ENVIRONMENTAL HAZARD MANAGEMENT PLAN

PALI HIGHWAY PROJECT CORRIDOR

February 24, 2020

F. CLARIFICATION QUESTIONS/REQUEST FOR INFORMATION AND HDOT RESPONSE

**FIGURE 3:
LEAD IMPACTED AREA MAP**

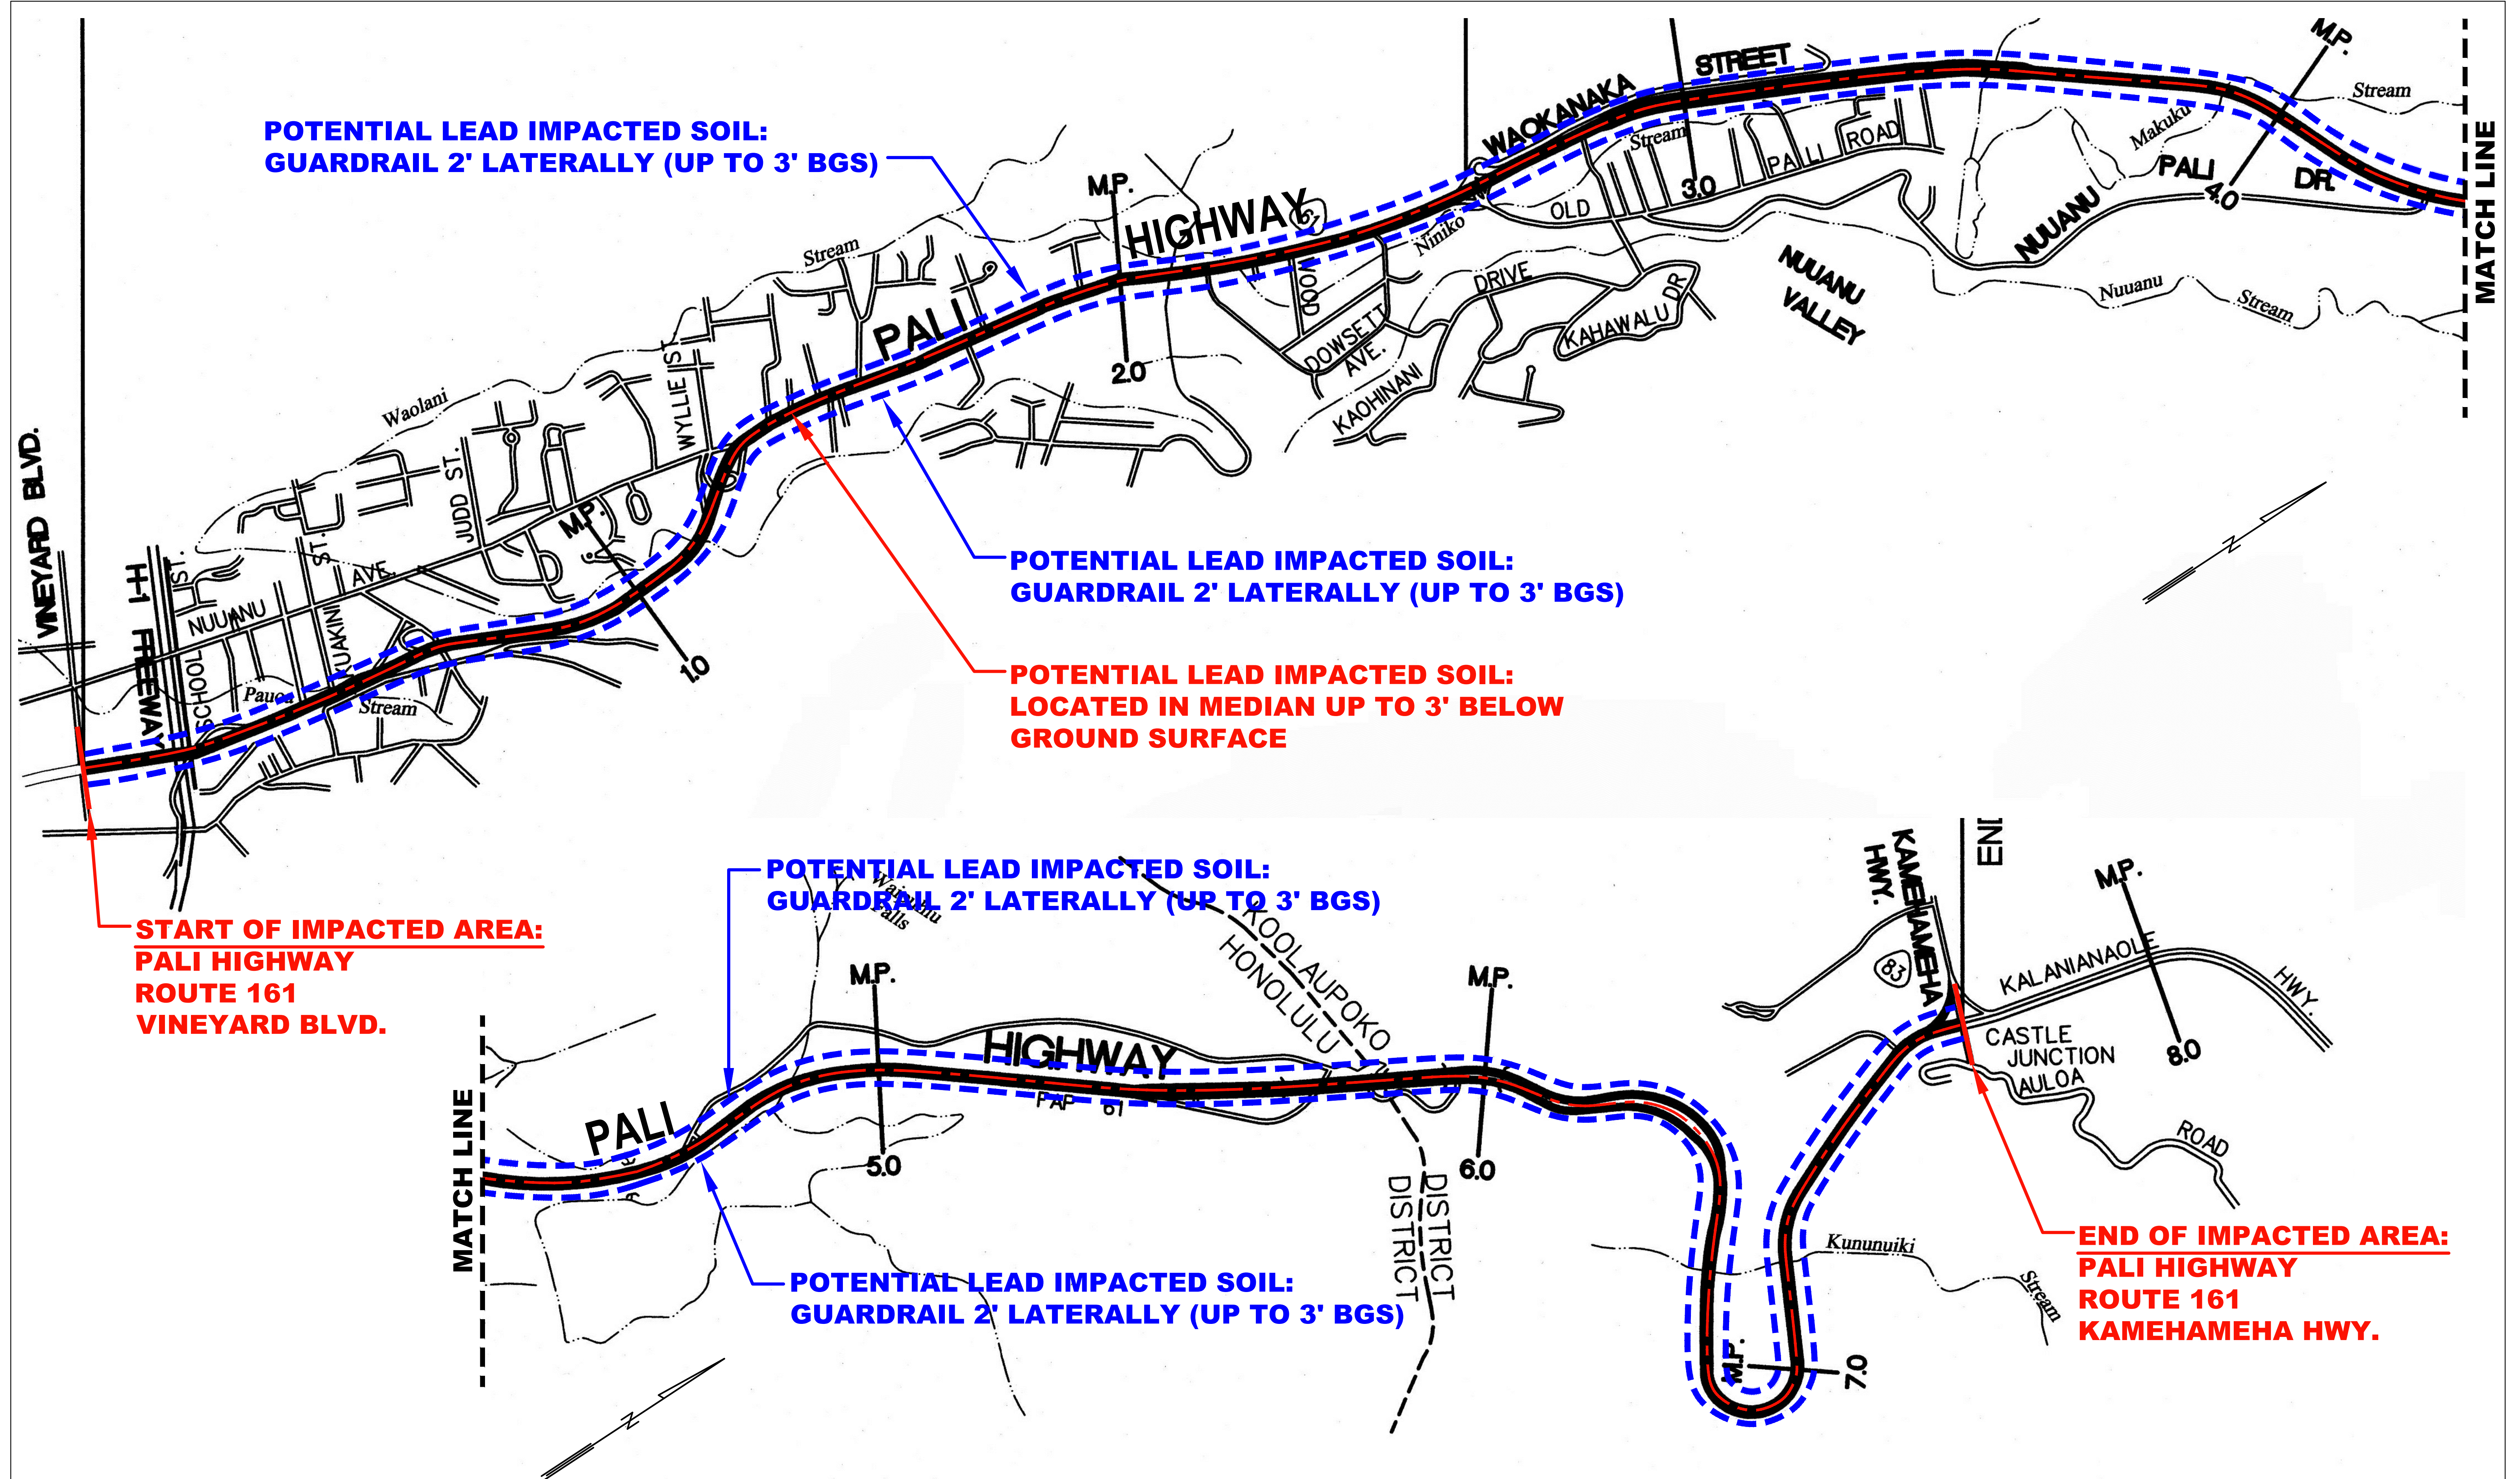
4. Question: With reference to bid item #657.1000, and SP section 657, and Standard Specification Section 107.16(A), request all pertinent information on the project's Environmental Hazard Management Plan (EHMP) as applicable, and any known locations of suspected contaminated or hazardous items or materials within the project limits.

Response: *Included in this Addendum is the Draft EHMP. The implementation of the EHMP will be extended to include the entire ROW.*
